# Access Compliance Report

## Public Rights-of-Way

Intersection ID: 31672	Main Street: EAVES_LN	Cross Street: PLAZA_WALK_DR	Location: NE
ADA ID: 27F21BA4B253	Ramp Type: BlendTrans1	Initial Pass/Fail: Fail	Overall Compliance: No
Severity Score: 8.75			
Codes/Mitigation Info/Possible Solution		Field Measurements/Component Compliance

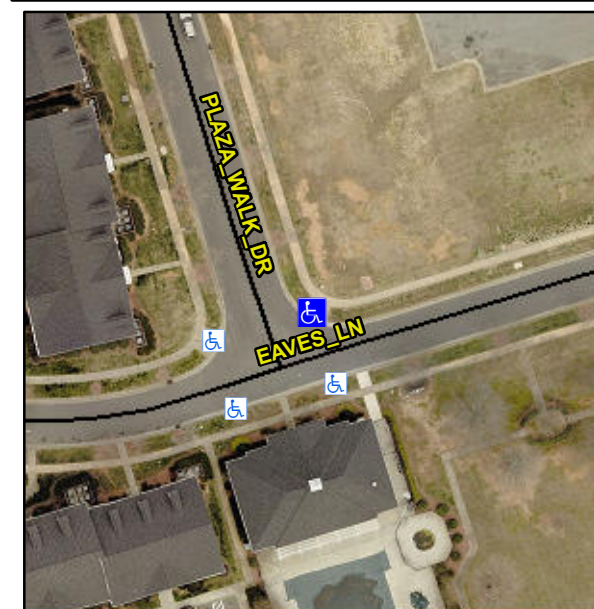
**R304.5.1**

**Remove & Replace Curb Ramp With Two New Directional Ramps or Equivalent.**
